SUBJECT: Forwards addl info re 851009 Proposed Change 200 to Tech
 Specs, reducing max concentration of boric acid stored in
 makeup tanks, per NRC request. CEN-316(s), "Boric Acid Makeup
 Tank Concentration..." encl.

Subject: Docket Nos. 50-361 and 50-362
San Onofre Nuclear Generating Station
Units 2 and 3

BORIC ACID MAKEUP CONCENTRATION REDUCTION EFFORT
RESPONSE TO NRC REVIEW QUESTIONS

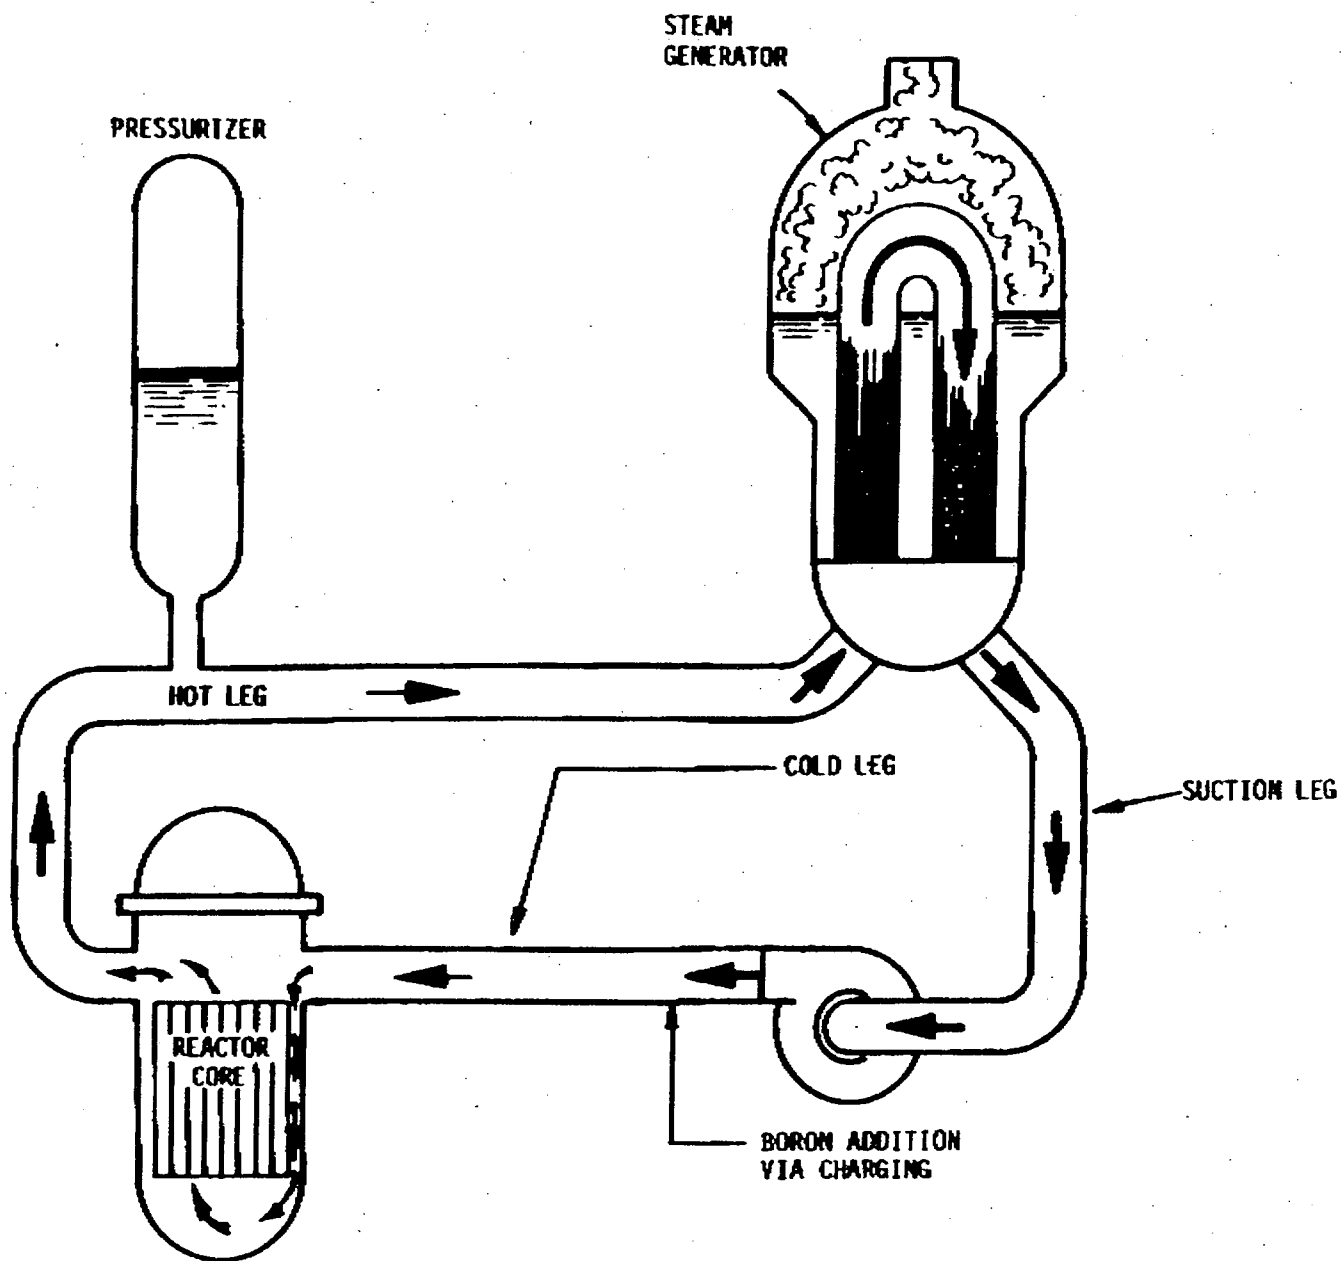
Question 2: Under natural circulation conditions, how fast does boron mix in the RCS?

Reference 4.3 of CEN-316(S) presented the results of two tests performed at San Onofre in order to demonstrate the ability to rapidly and completely mix boron in the reactor coolant system (RCS) under natural circulation conditions. A discussion of these tests as well as a summary of the various mechanisms that contribute to boron mixing are contained in Section 3.0 of that reference. Note, as presented in Reference 4.3 of CEN-316(S), a slug of concentrated boron added to the reactor will require approximately 30 minutes to completely mix with the entire volume in the RCS with approximately 80% of that mixing taking place in the first ten minutes. Also note that these same test results demonstrated the ability to rapidly borate the reactor coolant system concurrently with a plant cooldown.

The thirty minute mixing time discussed above is based upon a static mixing situation where a single slug of boron is added to the reactor coolant system and then monitored until complete mixing takes place. In contrast, a dynamic situation exists in the RCS for the case where the plant is being cooled and concentrated boron is being added as part of inventory makeup due to coolant contraction. In the dynamic situation, the boron concentration in the reactor vessel surrounding the core will actually be higher than indicated for the actual concentration curve at each time increment in Figure 2-5. This is true because of two conservatisms that were used to generate the actual concentration curve in that figure. The first conservatism is the assumption of complete and instantaneous mixing between all fluid added via the charging nozzles and the fluid in the RCS loops. In the dynamic situation that exists during an actual cooldown, concentrated boron would be continuously added to the RCS cold leg via the loop charging nozzle. The flow from the charging nozzle is directly into the vessel such that the concentrated boron would mix with the contents of the cold leg first and then mix with the contents of the reactor vessel. (See attached figure.) Therefore, the actual concentration that would exist within the vessel would be higher in the dynamic situation than shown in Figure 2-5 since complete and instantaneous mixing was assumed not only with the contents of the cold leg and the reactor vessel, but also with the contents of the hot leg, steam generator and suction leg.

The second conservatism that results in the concentration in the reactor vessel being higher than that indicated for the actual concentration curve at each time increments in Figure 2-5 is the assumption of complete and instantaneous mixing between all fluid added via the charging nozzle with the contents of the pressurizer. During a cooldown where an operator is charging only as necessary to makeup for coolant contraction, the driving force for mixing between the RCS and the pressurizer is small. This is the direct result of the fact that the surge line connecting the pressurizer to the hot leg is long, approximately 55 feet. As a result, instantaneous mixing with the pressurizer is a conservatism that results in calculated boron concentrations that are lower than would be seen for an actual cooldown.

Note: As discussed in Section 3.0 of CEN-259, boron added to the cold leg via charging will be 90% mixed prior to entering the reactor vessel downcomer.
